TECHNICAL BULLETIN INDEX
Sorted by Bulletin Number
04/03/86

BULLETIN NO: II:1

PRODUCT: 26-4001/2 Model II

Figure 1

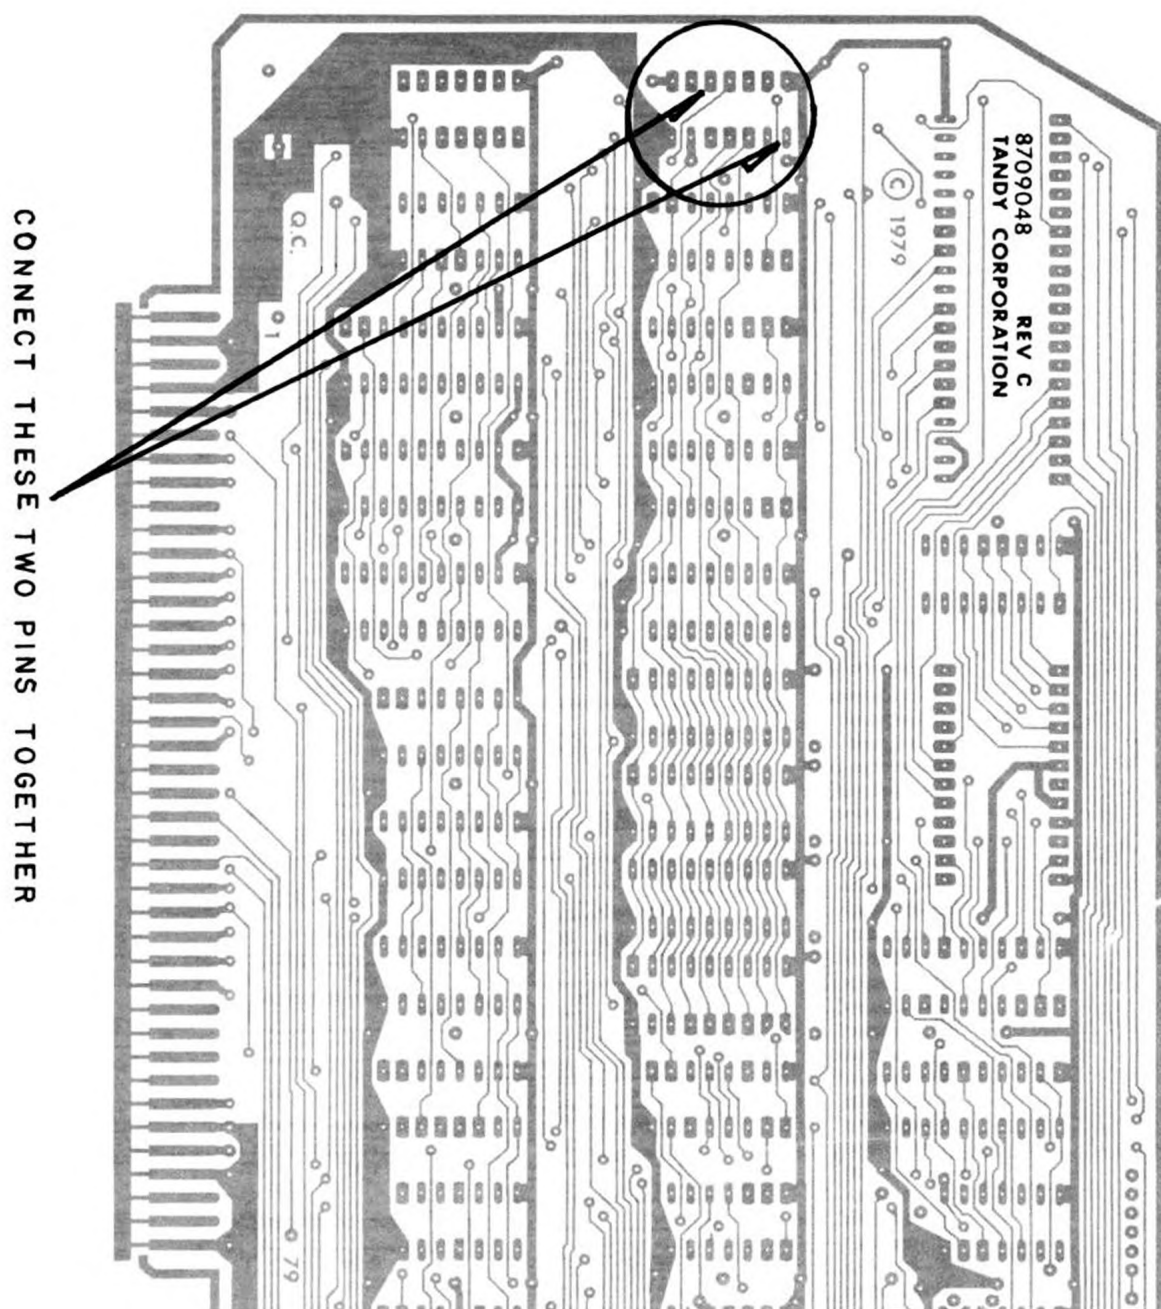
PURPOSE: To correct dual addressing on Video/Keyboard Interface boards (Rev A/B).

DISCUSSION: Rev A and B VDG boards have a problem with dual addressing. Addresses FC through FF are decoded on the VDG board for use by the Model II. There is an image of these addresses from 7C through 7F. Most systems will not have hardware port mapped at these addresses so no problem will appear. The only time a problem may arise is if a system has hardware installed that is port mapped in the range of 7C through 7F. This problem was corrected on Rev C VDG boards.

PROCEDURE: Whenever a Rev C VDG board is replaced with a Rev A or B VDG board jumper pin 1 to pin 10 of U27 on the Rev A or B board to insure no addressing conflict of the VDG board (Refer to Figure 1).

FIG 2

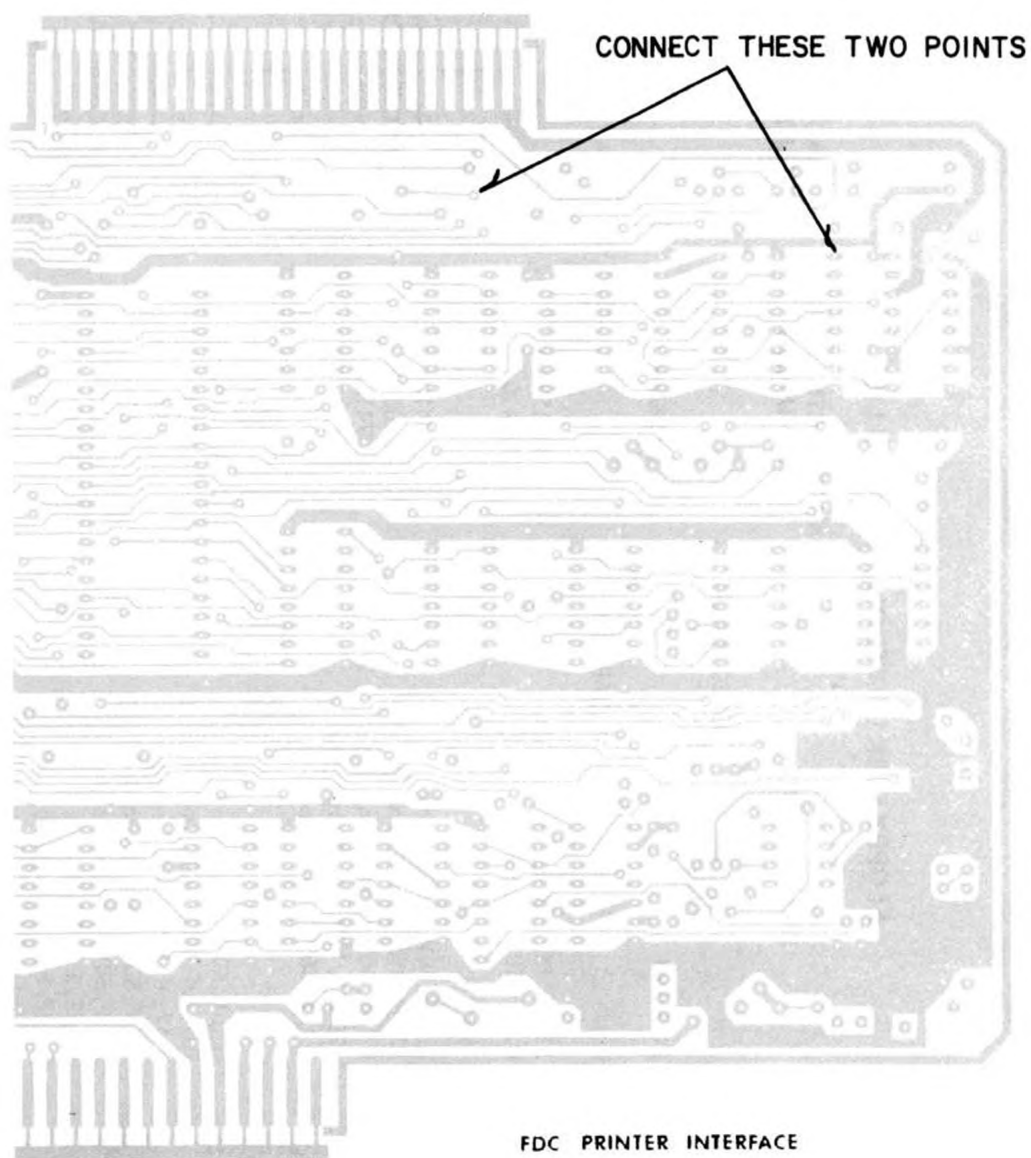
PURPOSE: To correct problem of not being able to format past Track 43.

DISCUSSION: Some early FDC boards may not be able to format past Track 43 with precomp set at the required specification of 250 nsec. This problem will occur ONLY with the SY1791-02 FDC chip (not the FD1791-02 FDC chip) because the EARLY pulse ends slightly sooner on the SY1791-02. This could lead to a double pulse being picked off the shift register. To correct this problem the data out is tied to the RESET of the shift register. As soon as the data triggers the one-shot, it then clears the shift register, preventing double data pulses (Refer to Figure 1).

PROCEDURE: On unmarked, Rev A, or Rev B boards make sure the "one shot" modification has been installed (Refer to Technical Bulletin II:9), or that long jumpers are installed on the back of the board running to U37. Disregard this step on Rev C and D boards as they have this modification incorporated into their circuitry. On ALL revisions of the current board with a SY1791-02 FDC chip installed, add a jumper wire on the back side of the board from U1 pin 1 to the trace connected to TP10 (Refer to Figure 2).

Figure 1

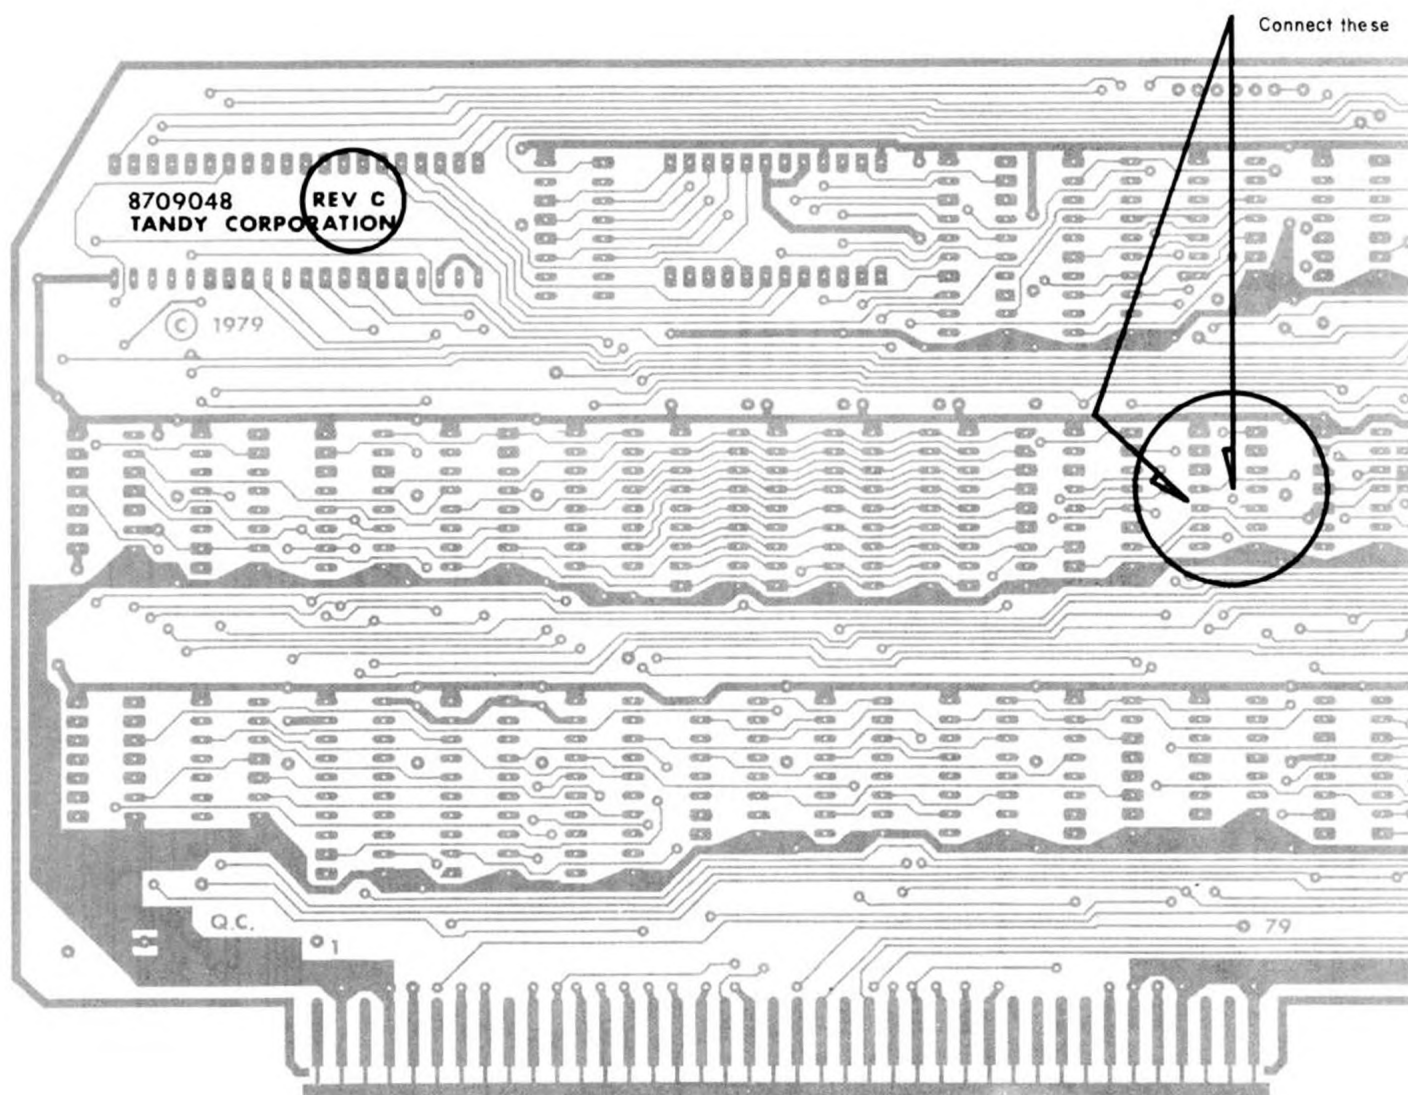
PURPOSE: To correct unexplained keyboard entries and/or machine lockup.

DISCUSSION: On Rev C VDG boards made by Lika there is a trace missing to the clear line on the latch (U17) that generates KBIRQ*. This can generate random interrupts that may or may not be fatal. To correct this problem a jumper is added to correct the missing trace which is a pullup to the clear line of U17. To identify the board as being manufactured by Lika, look for the Rev C marking on the solder side of the board under the 6845 chip and by LEI etched also on the solder side the crystal. This is the ONLY board to which this fix applies.

PROCEDURE: On the solder side of the board there is a feedthru located beneath the middle of U17 that is not connected to anything. Run a short piece of wire from that feedthru to U17 Pin 10 (Refer to Figure 1).

Figure 1

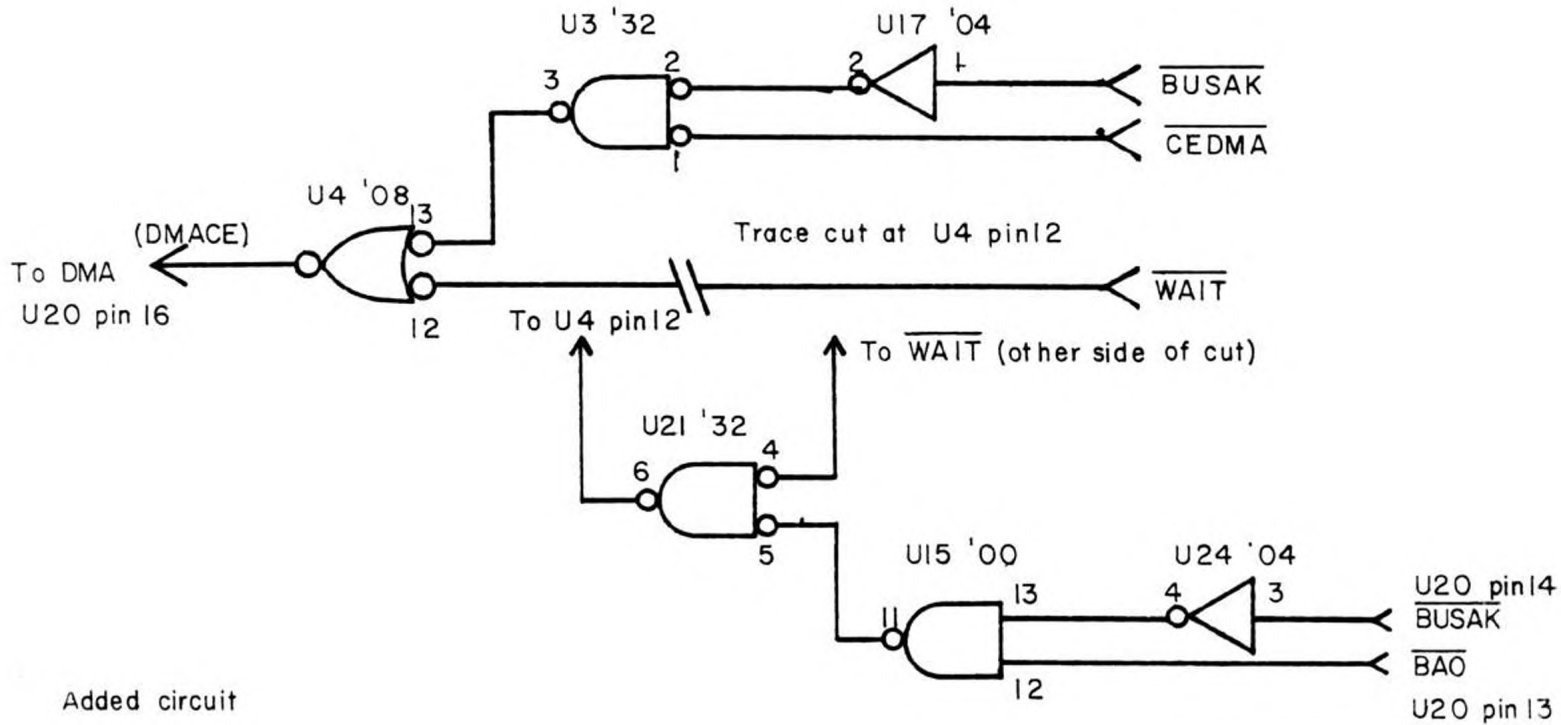
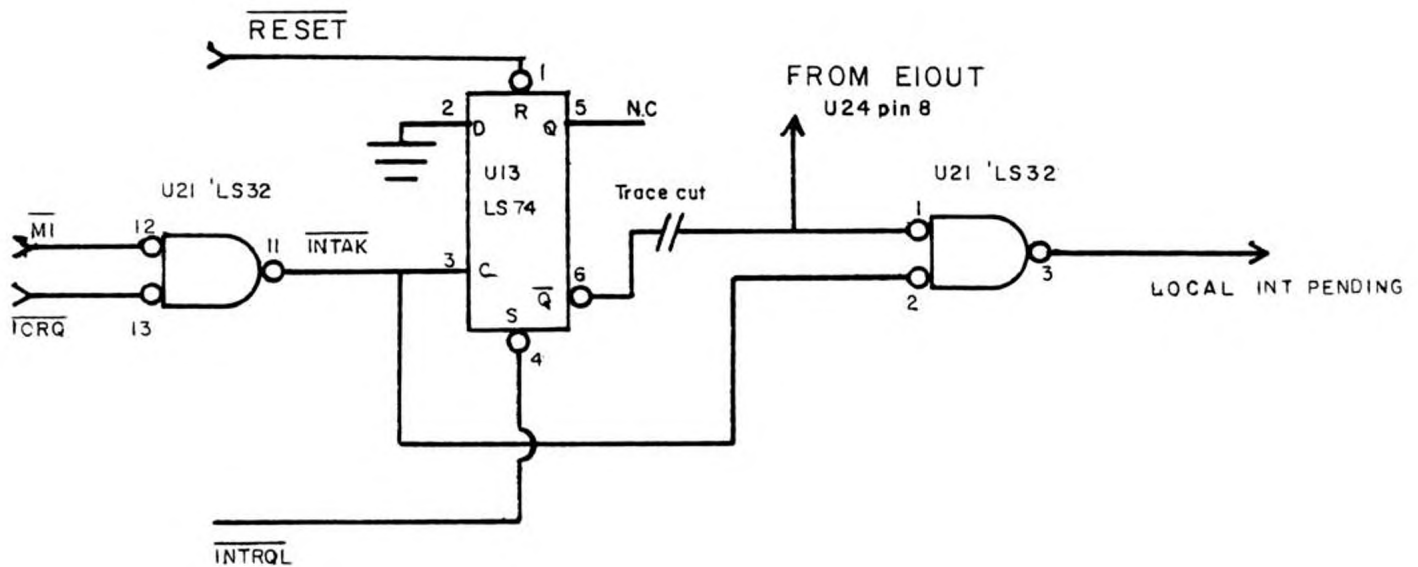
PURPOSE: To outline enhanced DMA modification procedure.

DISCUSSION: This modification is the same as the Hard Disk modification except it does not include anything unique to the Hard Disk such as the Boot ROM. Rev A,B, and C boards are the ONLY CPU boards to which this modification applies. DO NOT perform this modification on Rev D and later boards as they have this modification incorporated into their design. Refer to Figures 1 and 2 for schematic changes affected by this modification.

PROCEDURE: After determining that the Revision level of the board is a Rev A, B, or C perform the following procedure with all cuts and jumpers on the SOLDER SIDE of the board for consistency. Remember, DO NOT perform this modification on Rev D boards or later.

U21 pin 1 to U24 pin 8
U4 pin 12 to U21 pin 6
U21 pin 4 to WAIT* (the first feedthru after the cut at U4 pin 12)
U21 pin 5 to U15 pin 11
U15 pin 12 to U20 pin 13
U15 pin 13 to U24 pin 4
U24 pin 3 to U20 pin 14

Figure 1

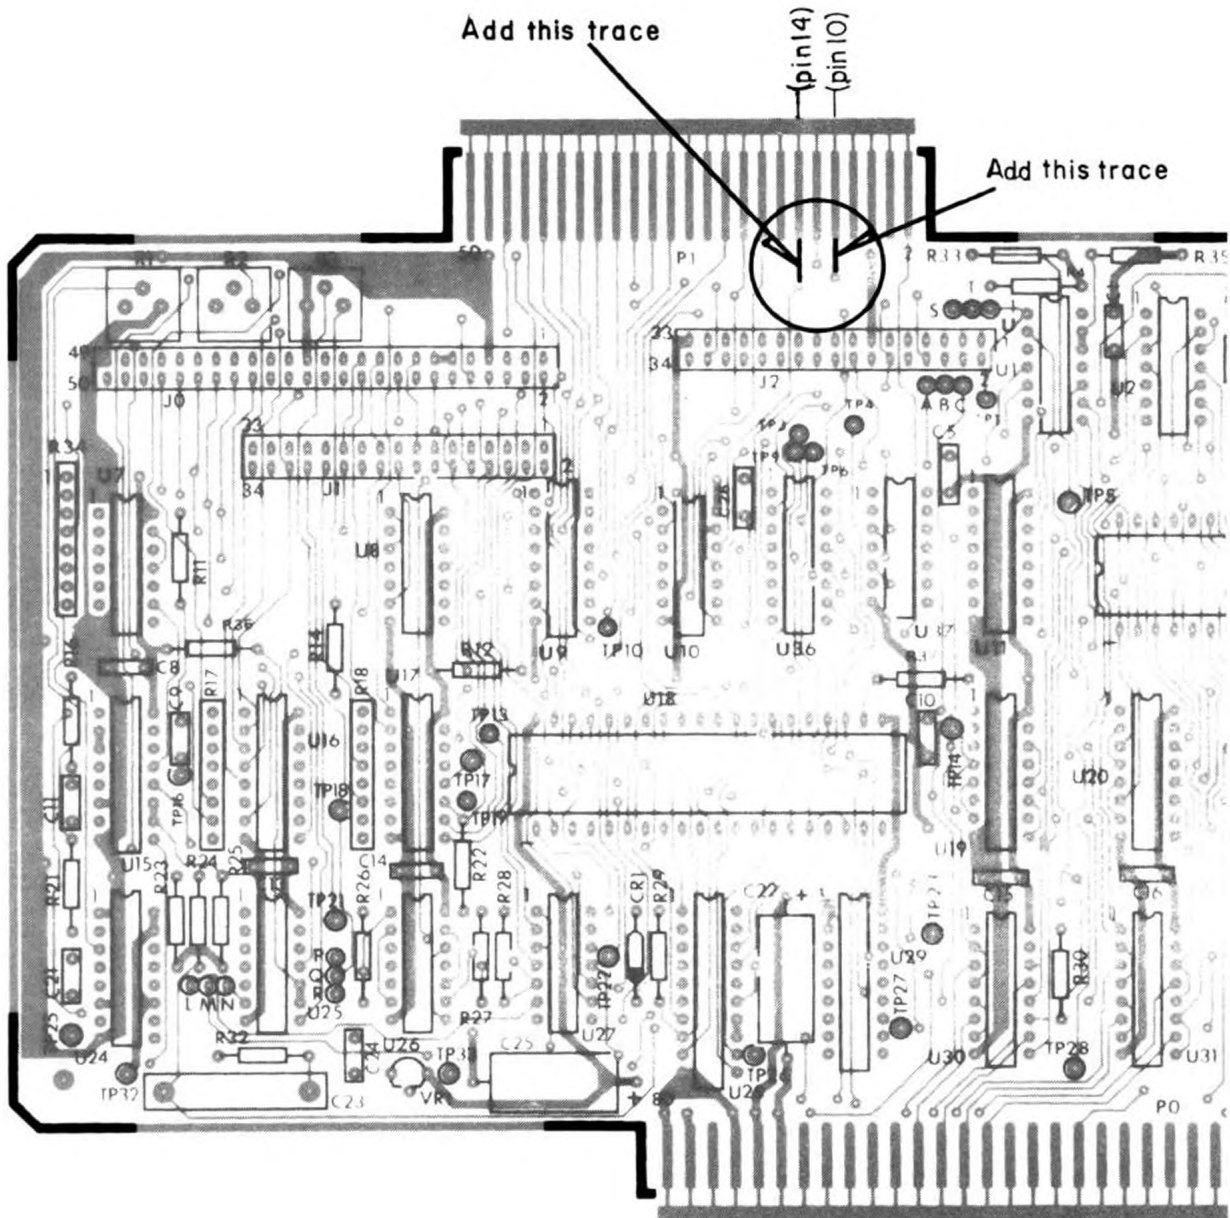
DISCUSSION: The trace that supplies the side select signal to the external drive connector on the Late Design FDC board (Rev Blank) is missing. Also, on some boards the trace that supplies the TWOSIDE* signal from the external drives to the FDC board is not present. Without these traces double sided drives cannot be used externally with the computer and will cause a problem with some diagnostics.

PROCEDURE: Refer to Figure 1 for the location of these traces. Run a jumper from pin 14 of connector P1 to the feedthru on the PCB that is directly in from the connector. Also run a jumper from pin 10 of connector P1 to the feedthru that is directly in from the connector.
